**BEFORE THE HEARINGS PANEL
FOR THE QUEENSTOWN LAKES PROPOSED DISTRICT PLAN**

**STATEMENT OF EVIDENCE OF MICHAEL ANDREW SMITH
ON BEHALF OF QUEENSTOWN LAKES DISTRICT COUNCIL**

**TRANSPORT
GENERAL INDUSTRIAL ZONE REZONINGS**

18 March 2020

Figure 4: Victoria Flats Road intersection details;
Source: Bing Maps ©.

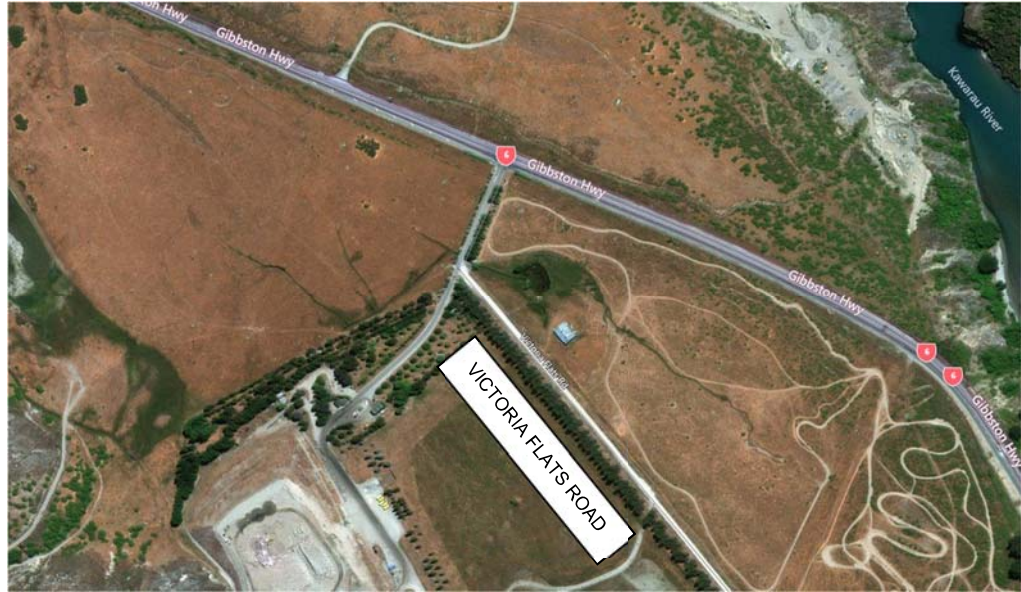
- 4.3** The current general low use of Victoria Flat Road (145 vpd: 2019 – Estimate; 10% HCV) results in a limited number of movements at the SH junction. It is acknowledged that the refuse tip is located down Victoria Flat Road.

Figure 5: Crash Data,
Source NZTA CAS Database

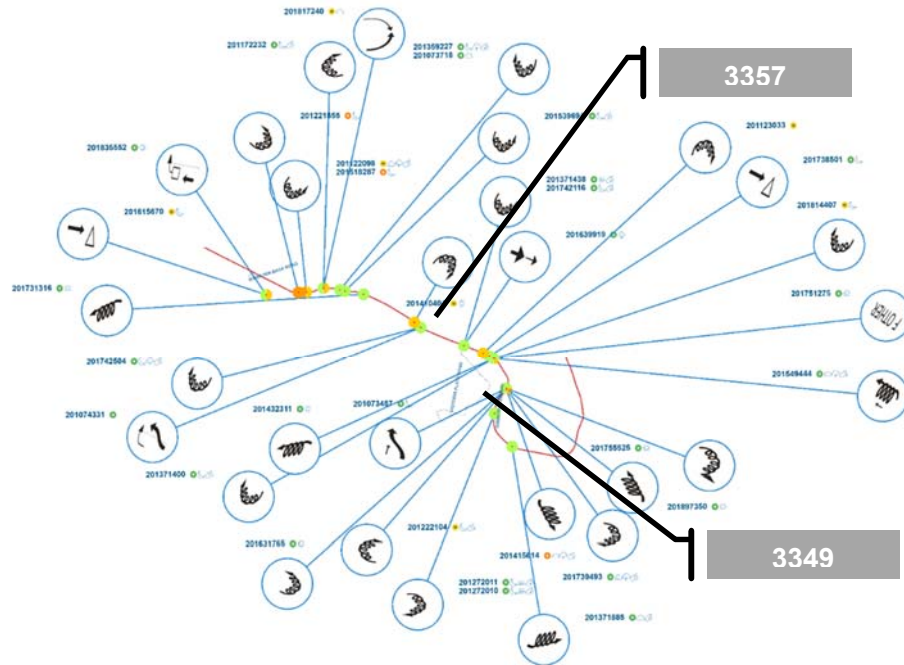
- 4.7 The above Figure is reproduced on an A3 format in Appendix 1 for clarity.
- 4.8 The crash records indicate a series of crashes that are loss of control – off road; straight, loss of control on curve, along with merge / turning crashes on the passing lane. A high proportion of the crashes are minor injury or non-injury crashes.

Figure 6: Submission 3349 site

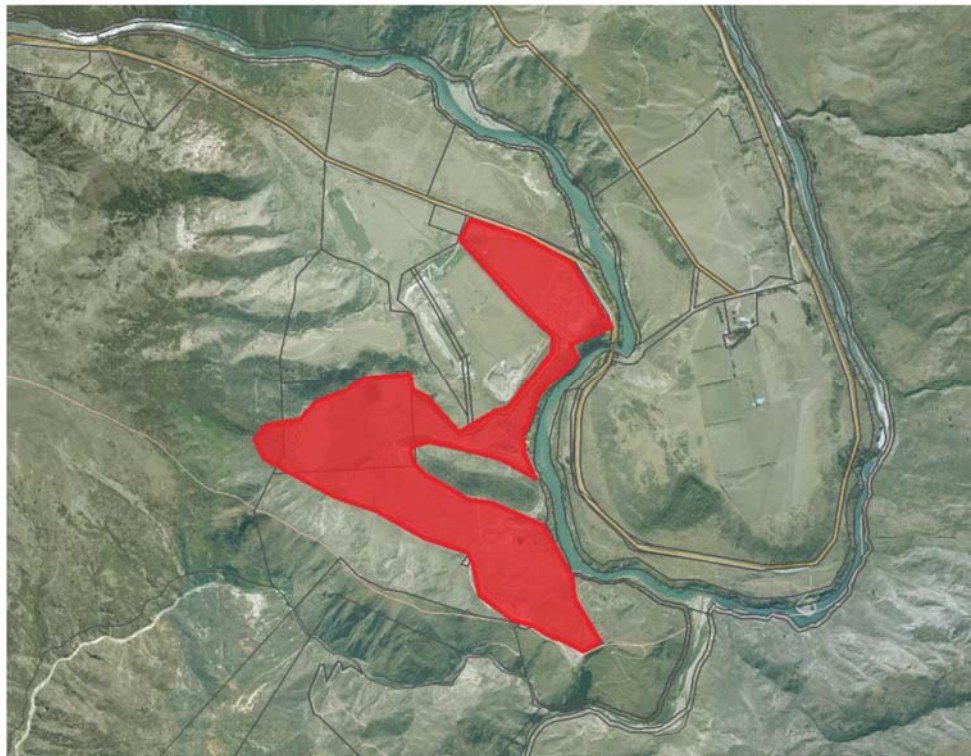
- 5.6** Victoria Flat Road intersection junctions SH 6 at the merge point of the passing lane. A right turn in provision has been made by isolated widening of the northbound shoulder, allowing drivers to pull left to make sure the road is clear to undertake a right-hand turn. It is also noted that an access to land / quarry is located some 200 m south, on the opposite side of the road from the submission site.

- 5.7** It is considered unsafe to form an access or side road at the termination end merge of a passing lane. Whilst Victoria Flat Road is located at this position, the consideration for the passing lane would have been cognitive of the current form and use, and the design adjusted accordingly.

- 5.8** A rezoning from Rural Zone and Gibbston Character Zone to General Industrial Zone would ultimately result in a much higher traffic volume from the area, and a greatly increased risk to all users. The NZTA Planning Policy Manual; Appendix 3E.7 details the general position of NZTA. This document states:

- 5.9** Visibility to the right on exit could be limited due to the masking of approaching vehicles (nearside lane hiding a faster approaching vehicle in the fast lane). In this instance a right-turn out vehicle, especially HCV, could result in a high-speed side impact with the HCV. This could not be supported for the current design of the passing lane. Forming the intersection as a left turn in / left turn out would result in users driving south and then undertaking a U-Turn movement to travel north. This would be considered unacceptable.

5.10 Considering the left turn out movement, this could be catered for with traffic utilizing the merge taper. This zone also acts as the safety run over zone (a zone whereby a late overtaking movement allows safe shoulder space for drivers to merge into a single file / undertake emergency braking). Additional treatments would be required to cater for the merge and slow acceleration of HCV from the site.

I disagree with this statement. An increase in side road traffic will have an adverse effect on the State Highway and its function due to the physical location of the side road junction at the terminating end of a passing lane. An increase in right turn in traffic will have an impact on the flow of northbound traffic.

I agree in part. Site generated traffic turn movements is a key element, however traffic generation and development style (type of business / industry etc) will determine origin / destination movements, along with vehicle type and volume. Larger vehicles (HCV) have a slow acceleration profile and could raise road safety risks for certain movements (i.e. Right Turn Out movement). Consideration will also have to be given to the current use by HCV through the operation of the landfill site, and how the proposed land use change would effectively and safely cater for this existing traffic movement.

I disagree. As stated in Para 5.7 above, it is considered unsafe to form an access or side road at the termination end merge of a passing lane.

5.12 In undertaking this review, I am of the opinion that this submission cannot be supported on traffic movement/safety grounds.
